**Origination Form**  
Proposed Revisions to a Standard Plans Index

<b>Originator:</b>	Stepp, Richard	<b>Index Number:</b>	521-404
<b>Date:</b>	8/28/2024	<b>Sheet Number(s):</b>	7
<b>E-mail:</b>	richard.stepp@dot.state.fl.us	<b>Index Title:</b>	Guardrail Transitions - Existing Post and Beam Bridge Railings (Narrow and Recessed Curbs)

**GUARDRAIL TRANSITIONS-EXISTING POST & BEAM  
BRIDGE RAILINGS (NARROW & RECESSED CURBS)**

**SCHEME 5**

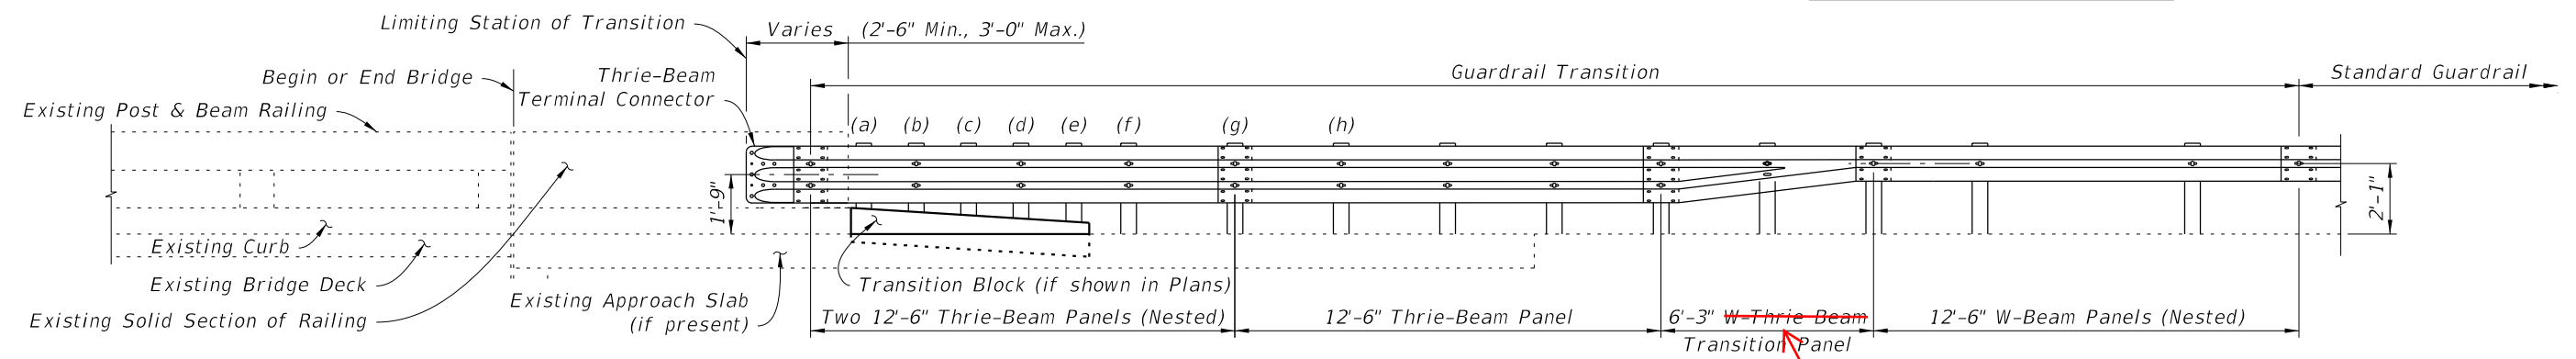
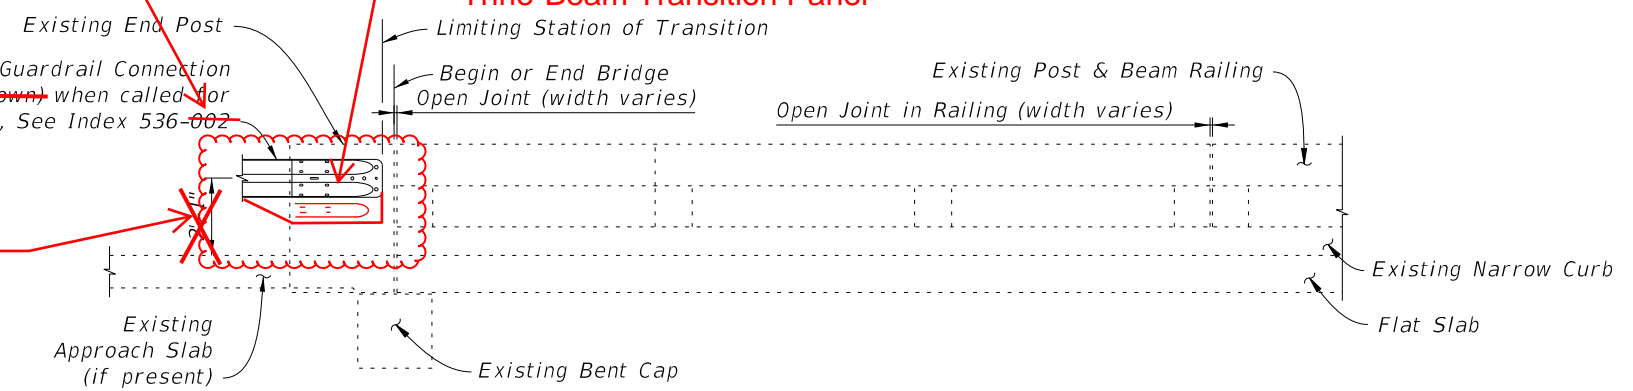
**CHANGED: "W-Thrie Beam" to "Thrie-Beam"**

**CORRECTED:**  
Reference to  
Index 536-001

**SCHEME 6**

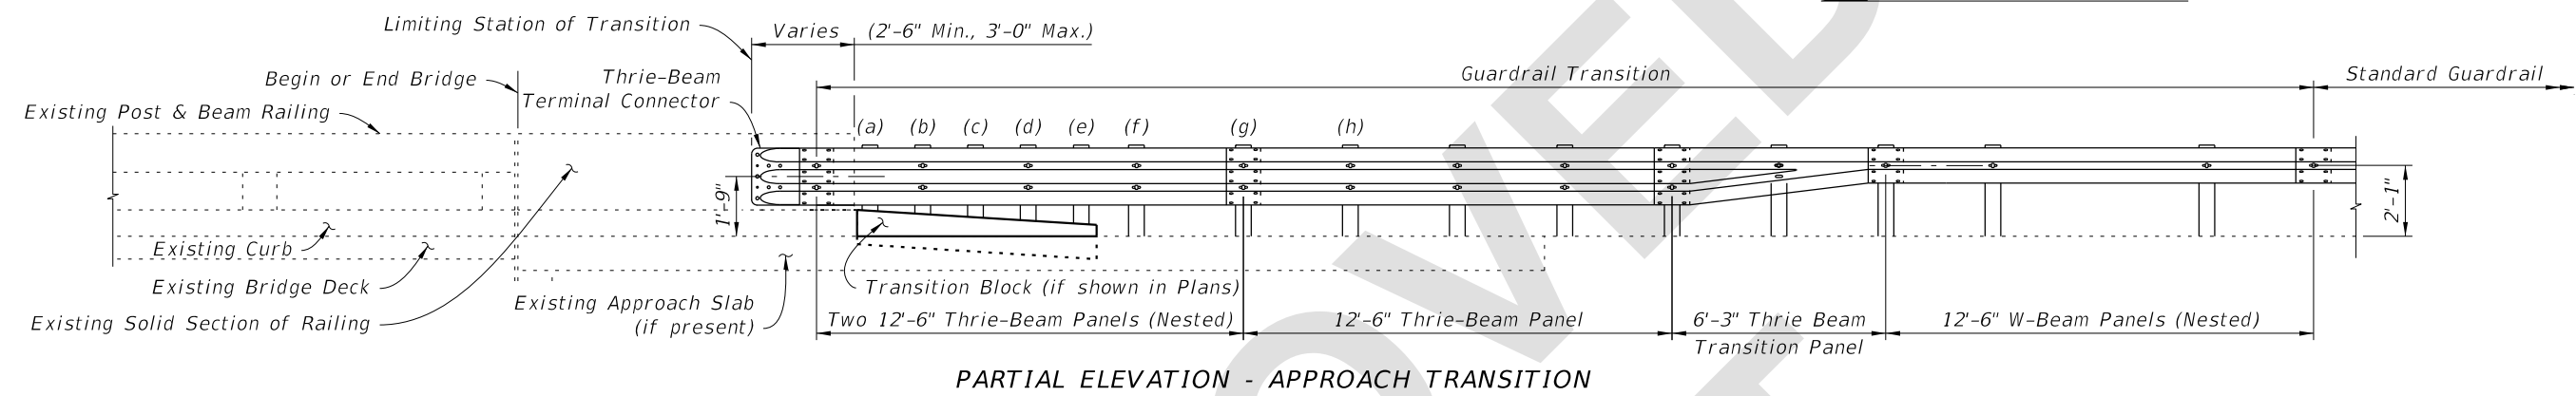
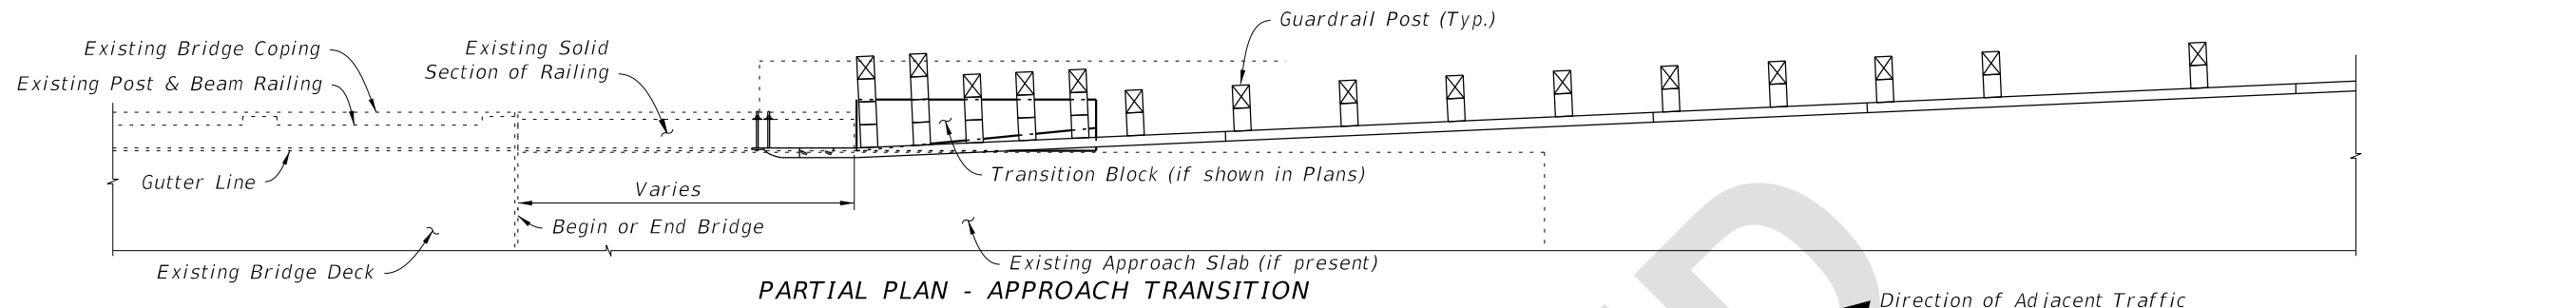
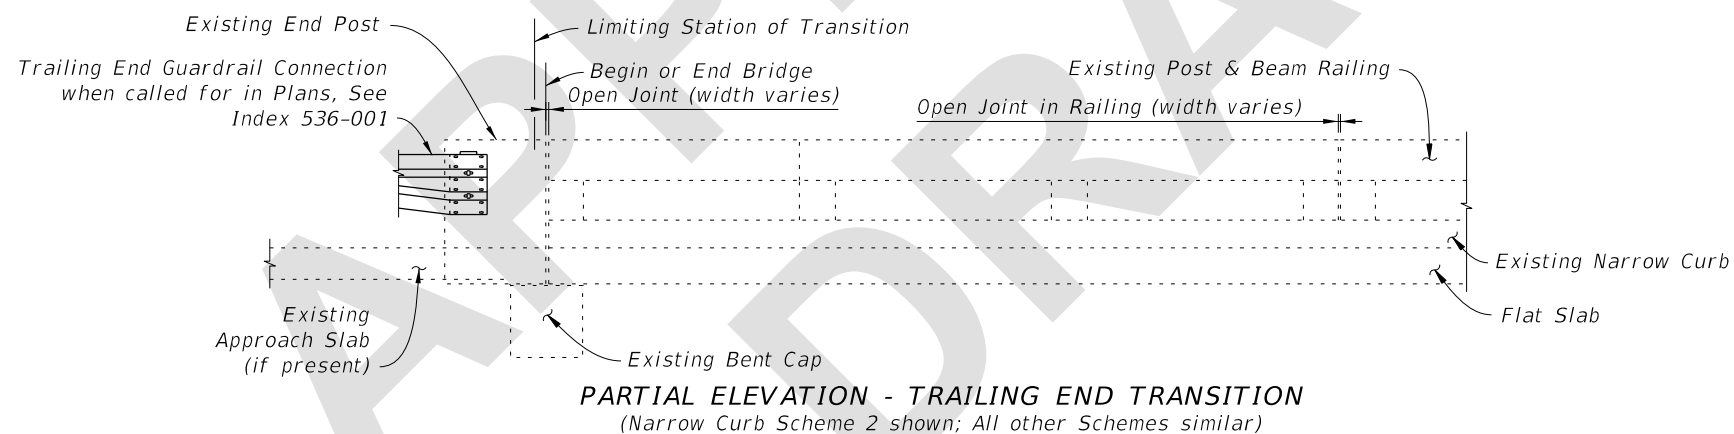
**CHANGED:**  
Trailing End Guardrail connection to show  
"Thrie-Beam Terminal Connector" and  
"Thrie-Beam Transition Panel"

**Removed old  
W-Beam wording**

**REMOVED:**  
Vertical  
Dimension
